## **DOWNTOWN MOBILE AREA CHAMBER OF COMMERCE SUBDIVISION**

Engineering Comments: FINAL PLAT COMMENTS (should be addressed prior to submitting the FINAL PLAT for review and/or signature by the City Engineer):

APPLICATION NUMBER 8 DATE March 2, 2023  
APPLICANT Downtown Mobile Area Chamber of Commerce Subdivision  
REQUEST Subdivision

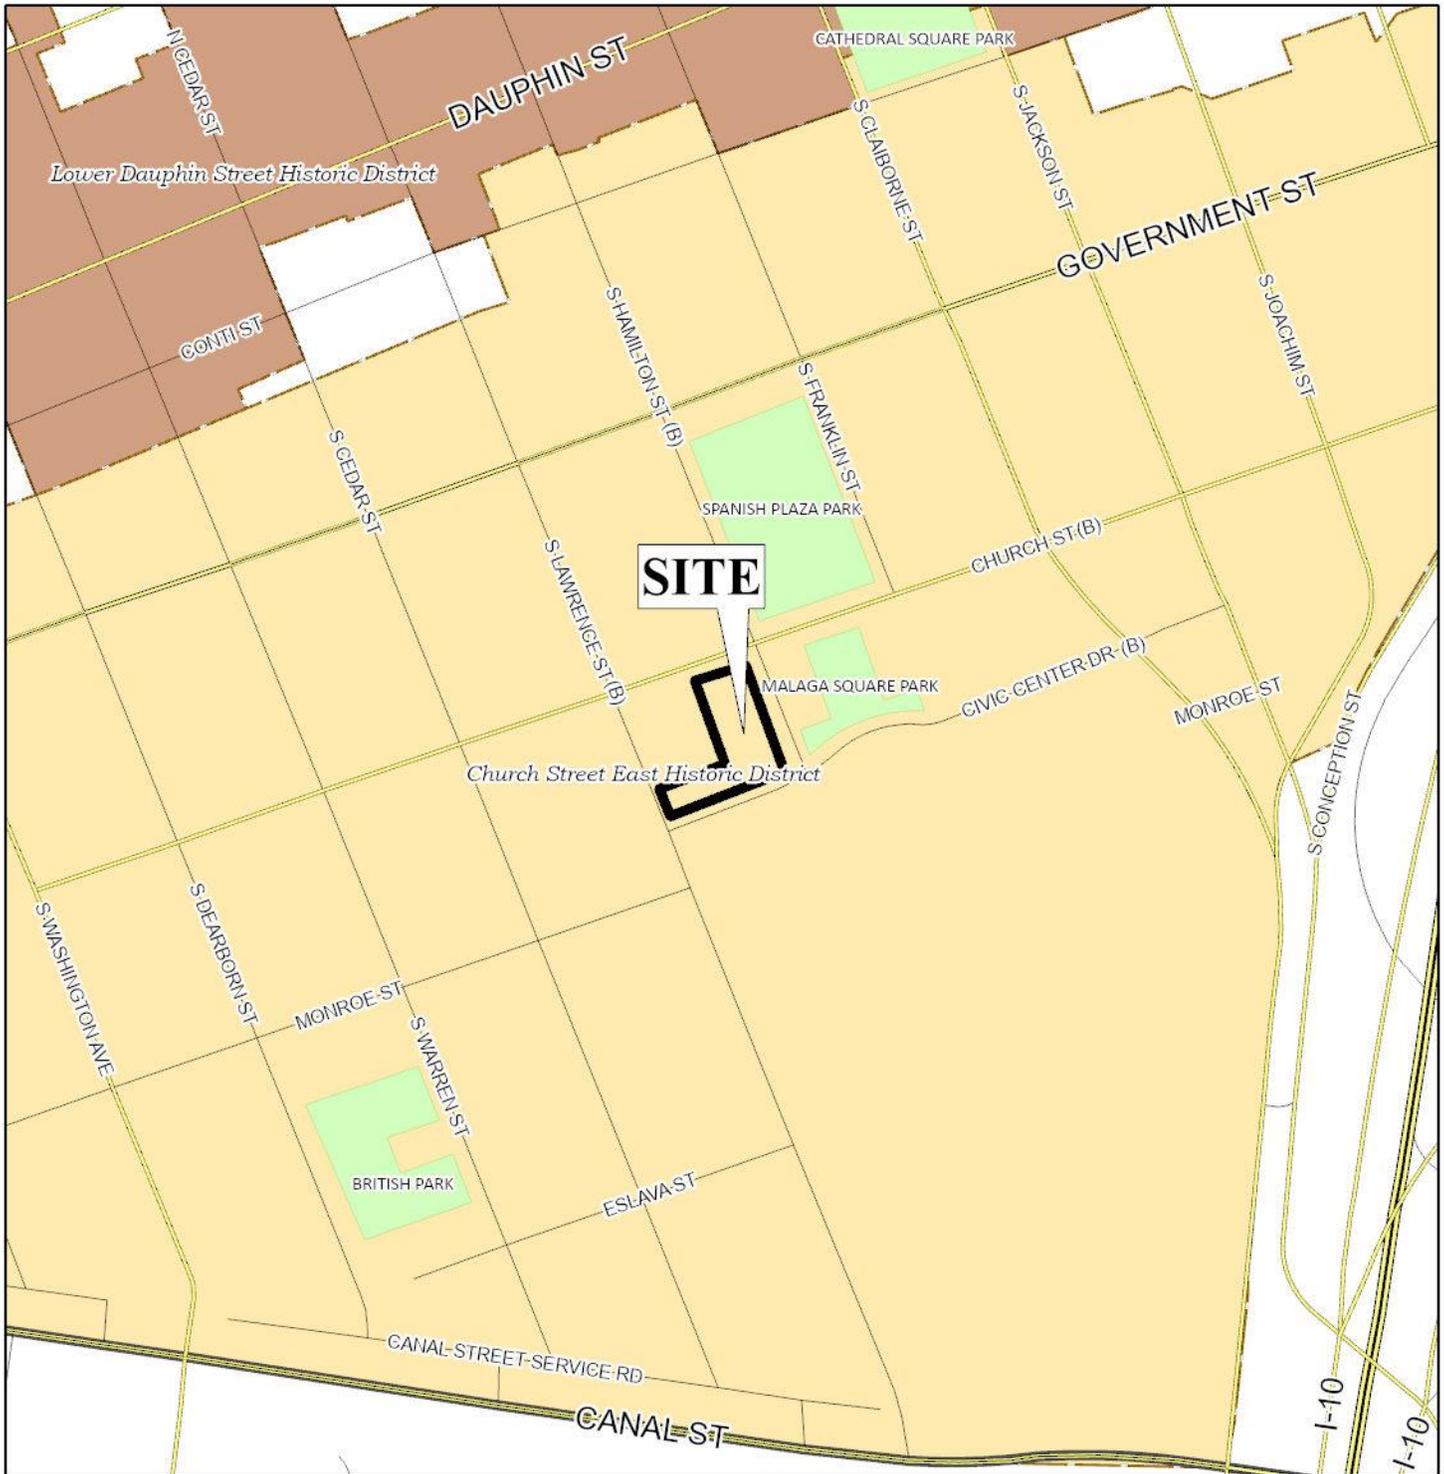
The proposed lot fronts Church Street, a major collector street on the Major Street Plan, with an existing compliant right-of-way. The site also fronts South Hamilton Street, Civic Center Drive, and South Lawrence Street, all minor streets with curb and gutter. South Hamilton Street and Civic Center Drive have existing compliant rights-of-way. South Lawrence Street should have a minimum of a 50-foot right-of-way, per V.D.14. of the Subdivision Regulations, however, several Subdivisions have occurred along this portion of South Lawrence Street, with no additional dedication required, therefore it may be appropriate to waive this requirement. If the Engineering Department determines it necessary, dedication of the curb radii, per Section V.D.6. of the Subdivision Regulations should be required.

The DDD requires that for properties abutting multiple frontages, the property owner shall designate one frontage as the primary frontage. The DDD prohibits parking access from a primary frontage, when a secondary frontage is available. It should be noted that properties in a T-4 sub-district are to be between 18-120 feet wide along the primary frontage. Lot 1 has an existing curb cut to South Hamilton Street, but the existing use of the site as a parking lot does not indicate which frontage should be the primary frontage. A note should be placed on the Final Plat indicating which street will be the primary frontage for Lot 1. The existing structure on Lot 2 faces Civic Center Drive, and as such is the primary frontage for the proposed lot. As proposed, Lot 2 has approximately 220-feet of linear street frontage, which does not comply with Chapter 64-3.I. 8.(b)(2) of the Zoning Ordinance. Therefore, if approved, either the primary entrance of the existing structure will need to be reconfigured to front South Lawrence Street to allow that street to be utilized as the frontage, or a variance from the Board of Adjustment will be required to allow the non-compliant lot width.

Furthermore, driveways in a T-4 sub-district are limited to 10-feet in width within the front setback. If approved, a note should be placed on the Final Plat stating this information. If the site is re-developed, the existing curb cuts to South Hamilton Street and Civic Center Drive will need to be reconfigured to comply.

The Subdivision Regulations require a minimum building setback of 25-feet along all public street frontages, whereas the DDD requires a 12-foot maximum setback along public street frontages. If approved, Section V.D.9. of the Subdivision Regulations should be waived, with a note placed on the Final Plat stating that setbacks must comply with the underlying zoning district of the property.

The lot sizes are provided in square feet and acres, and if approved, should be retained on the Final Plat, adjusted for any dedication.

Based upon the preceding, the plat is recommended for Tentative Approval, with a waiver of Section V.D.9. and V.D.14. of the Subdivision Regulations, subject to the following conditions:

- 1) dedication of the corner radius at Church Street and South Hamilton Street, Civic Center Drive and South Hamilton Street, and Civic Center Drive and South Lawrence Street, if deemed necessary and appropriate by the Engineering Department (or waive Section V.D.6. of the Subdivision Regulations);

- 2) placement of a note stating that any re-development of the property must comply with the requirements of the Downtown Development District (DDD);
- 3) placement of a note designating which street is primary frontage for Lot 1;

- 4) either reconfiguration of the primary entrance of the existing structure on Lot 2 to face South Lawrence Street to utilize it as the primary frontage, or obtain a lot width variance from the Board of Adjustment to allow Civic Center Drive to be the primary frontage for Lot 2;

- 5) placement of a note on the Final Plat stating that setbacks must comply with the underlying zoning district of the property;
- 6) retention of the lot size in both square feet and acres, or the furnishing of a table on the Final Plat providing the same information, adjusted for any required dedication;

- 7) placement of a note stating that driveways are limited to 10-feet in width within the front setback along the frontage, and are only allowed on secondary frontages;
